# **IGLESIA CAMINO DEL REY CHURCH**

**7604 FM 969 RD  
SP-2015-0372C**

***Pamela Abee-Taulli***

# SP-2015-0372C

# **VARIANCE ONE**

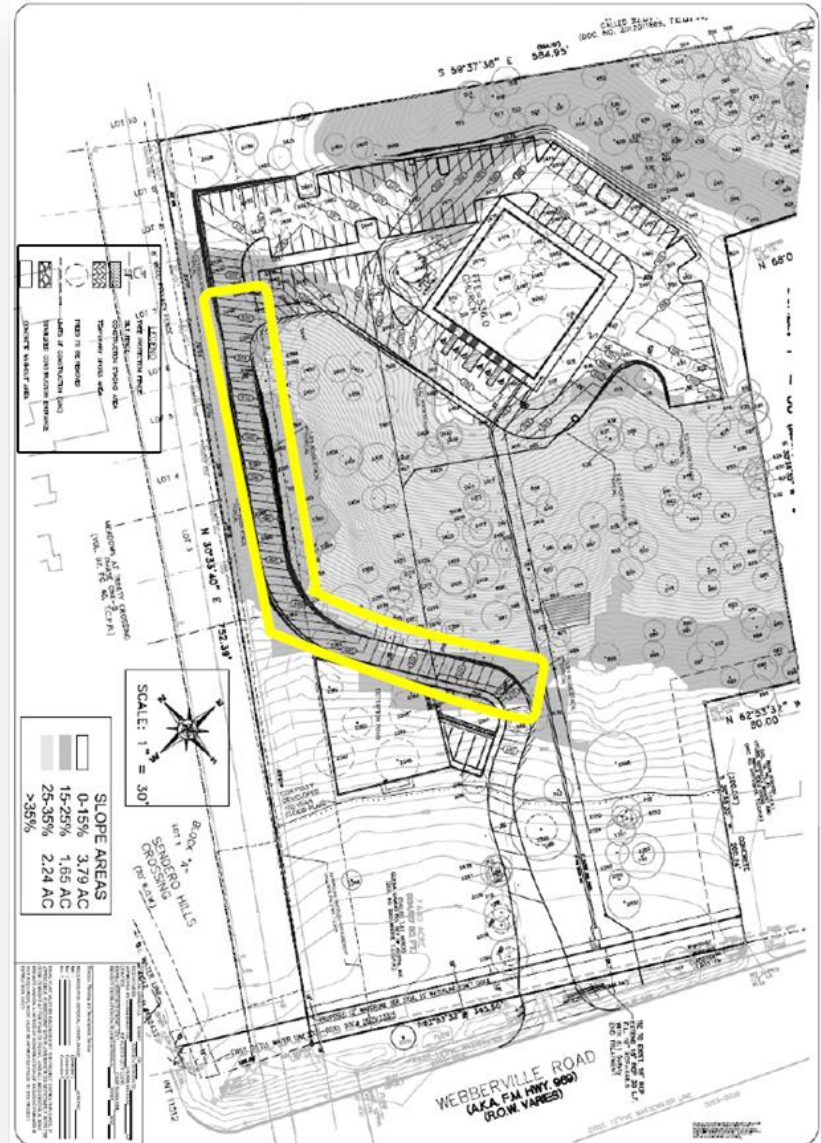
**Construction of a roadway or driveway on slopes.**

- **Prohibits construction of a roadway or driveway on a slope with a gradient of more than 15 percent unless the construction is necessary to provide primary access to:**
  - 1.** At least two contiguous acres with a gradient of 15 percent or less; or
  - 2.** Building sites for at least five residential units.

Construction  
of a roadway  
or driveway on  
slopes.

## **VARIANCE TWO**

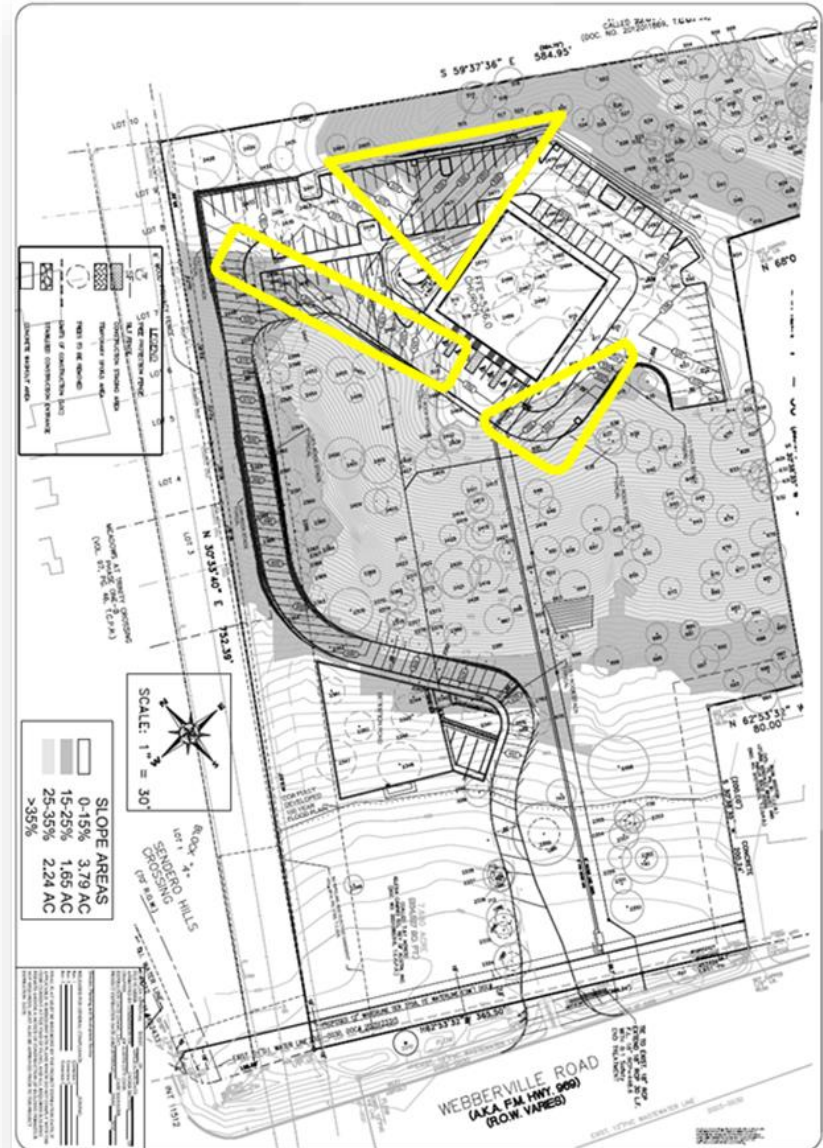
Construction of building or parking area on slopes.

- Prohibits construction of a parking area (surface parking) on a slope with a gradient of more than 15 percent.

Construction  
of a building  
or parking  
area on  
slopes.

# **VARIANCE THREE**

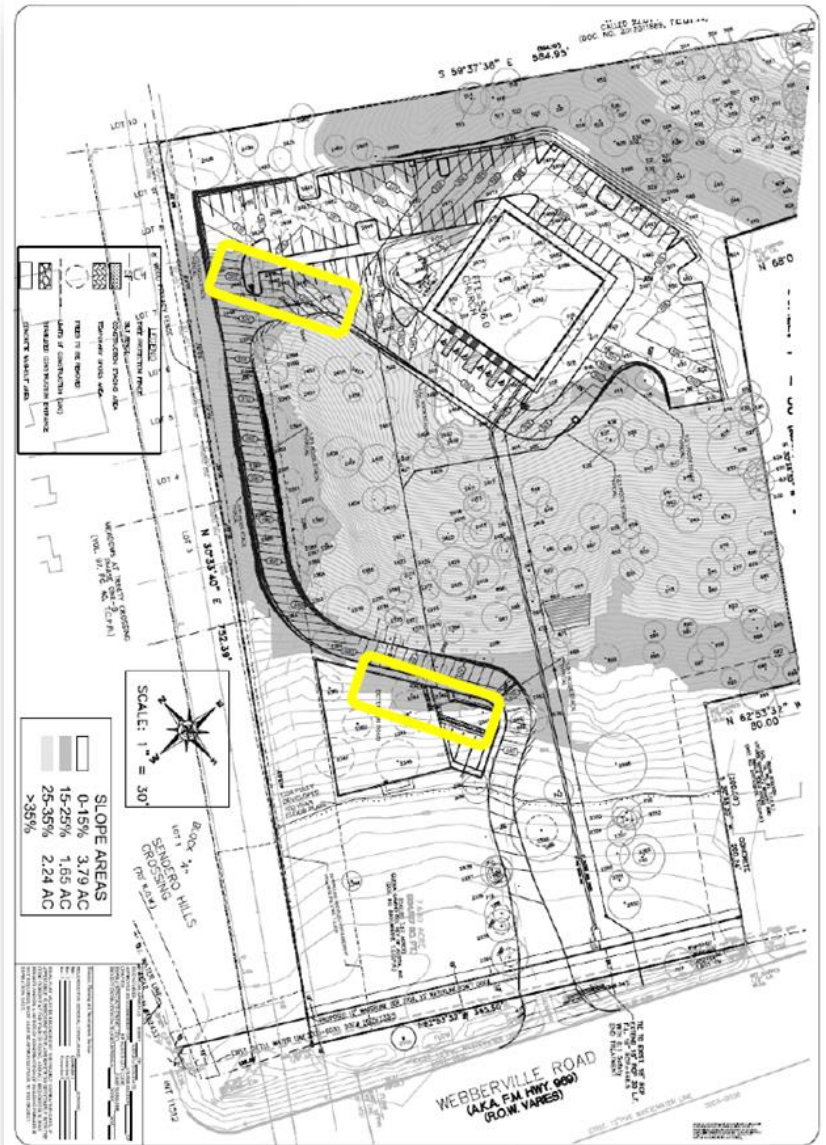
### **Cut requirements.**

- **Prohibits cut exceeding 4 feet.**
  - 25-8-42(B)(7), granting an administrative variance for cut exceeding 4 feet, does not apply on a slope with a gradient of more than 15 percent. [LDC 25-8-42(D)(4)]

Cut exceeding  
4 feet on slope  
exceeding 15  
percent.

# **VARIANCE FOUR**

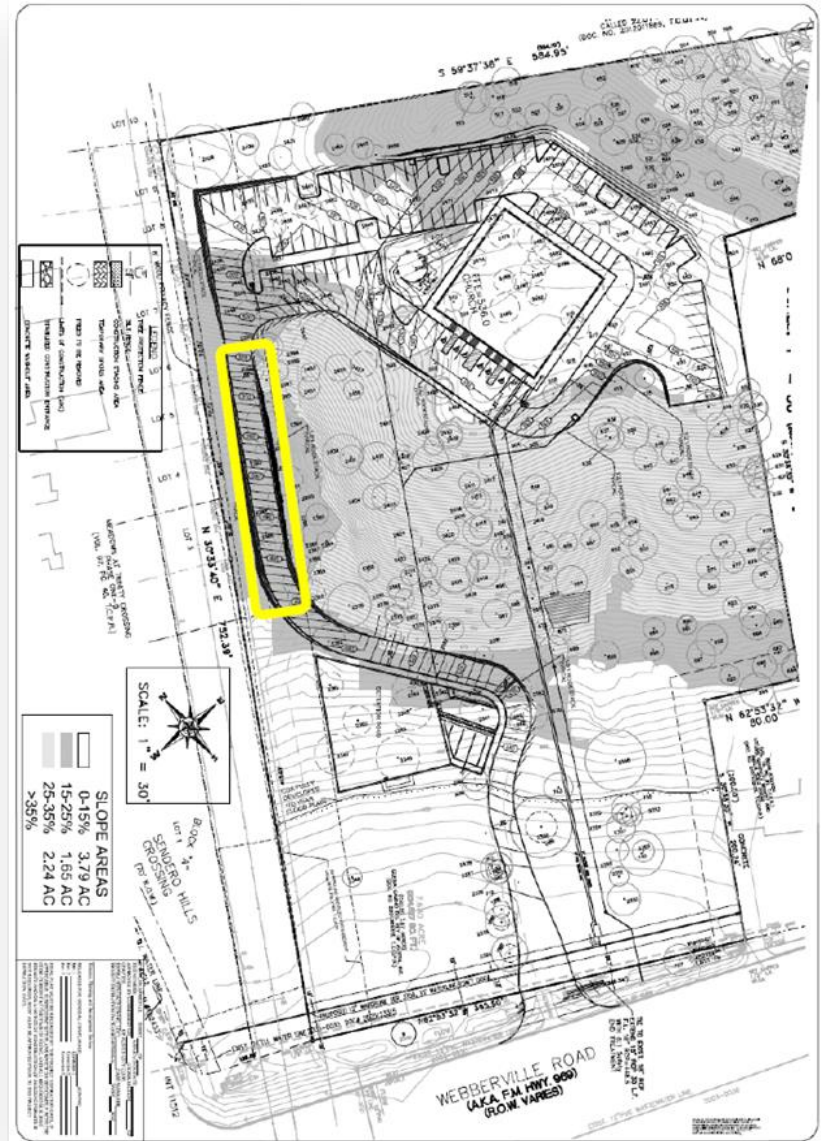
### **Fill requirements.**

- **Prohibits fill exceeding 4 feet.**
- 25-8-42(B)(7), granting an administrative variance for fill exceeding 4 feet, does not apply on a slope with a gradient of more than 15 percent. [LDC 25-8-42(D)(4)]

Fill exceeding  
4 feet on slope  
exceeding 15  
percent.
